#### Working Party on General Safety Provisions

117th session

## Report of the Working Party on General Safety Provisions on its 117th session

### Proposal for amendments to UN Regulation No. [151] (Blind Spot Information Systems for Heavy Vehicles)

Appendix 1, Figure 1, amend to read:

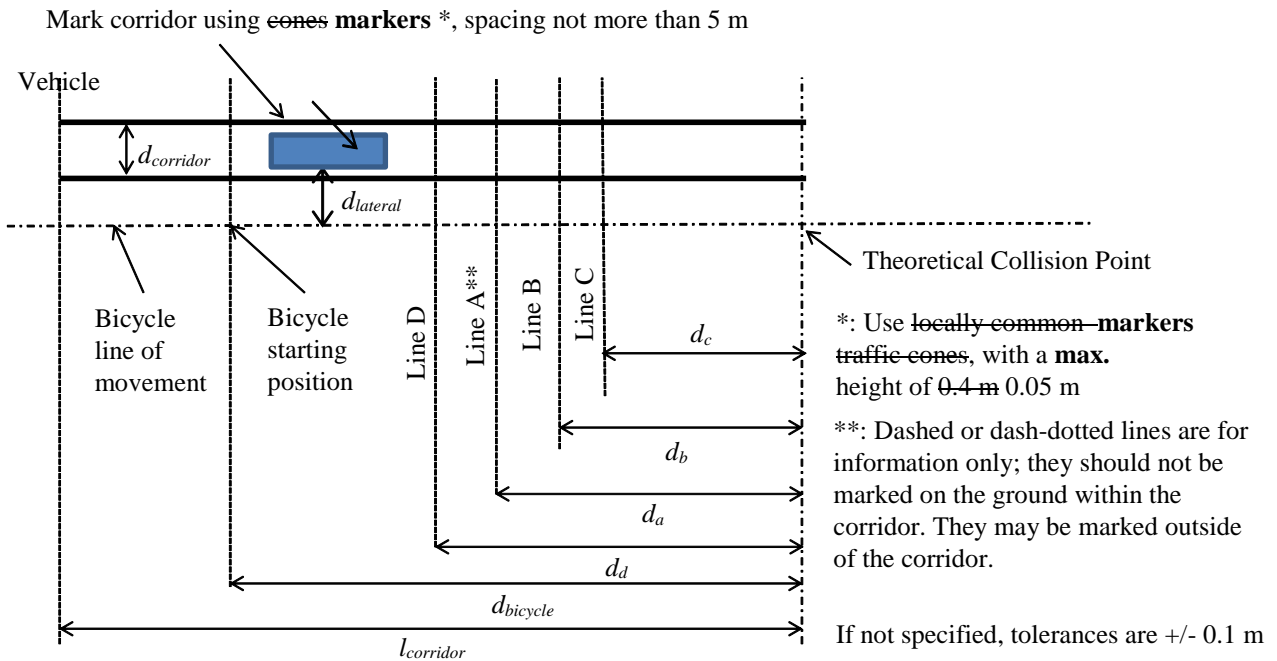
Where this is deemed justified, the Technical Service may select **additional** test cases different than shown in Table 1 of Appendix 1, within the range of vehicle speed, bicycle speed and lateral clearance as indicated in paragraphs 5.3.1.3. and 5.3.1.4.

The Technical Service shall check that the parameter combination in the selected test cases would lead to a collision between the bicycle and the vehicle with an impact position in the range as specified in paragraph 5.3.1.4. and shall assure that the vehicle is moving with the selected speed when crossing line C in Figure 1 of Annex 1 by appropriately adjusting starting distances and corridor length for the vehicle and the bicycle.

**The criterium “first point of information” is deemed to be complied with when test cases other than those from table 1 in appendix 1 to this regulation are carried out.”**

6.5.10. The test is passed when the Blind Spot Information signal has been activated in all test cases as shown in Table 1 of Appendix 1 to this Regulation before the **foremost point of the vehicle has reached** ~~crossed~~ line C **but not before the foremost point of the vehicle has reached line D** (see paragraph 6.5.7. above, **where line D is only relevant for test cases taken from Table 1 of Appendix 1**) and the Blind Spot Information signal has not been activated in any test run when the vehicle passes the traffic sign (see paragraph 6.5.8. above). **However, the information signal is not required when the relative longitudinal distance between bicycle and front right corner of the vehicle is more than [30] m to the rear or [7] m to the front.**

For vehicle speeds up to 5 km/h, it is deemed satisfactory if the information signal is activated 1.4 seconds before the bicycle has reached the theoretical collision point as specified in Appendix 1, Figure 1. ~~For vehicle speeds between 5 and 10 km/h, the value  $d_c$  shall be 5 m.~~

For vehicle speeds above 25 km/h, where the stopping distance is higher than 15 m,  $d_c$  as specified in Appendix 1, Figure 1 shall be as specified in Appendix 1, Table 2.
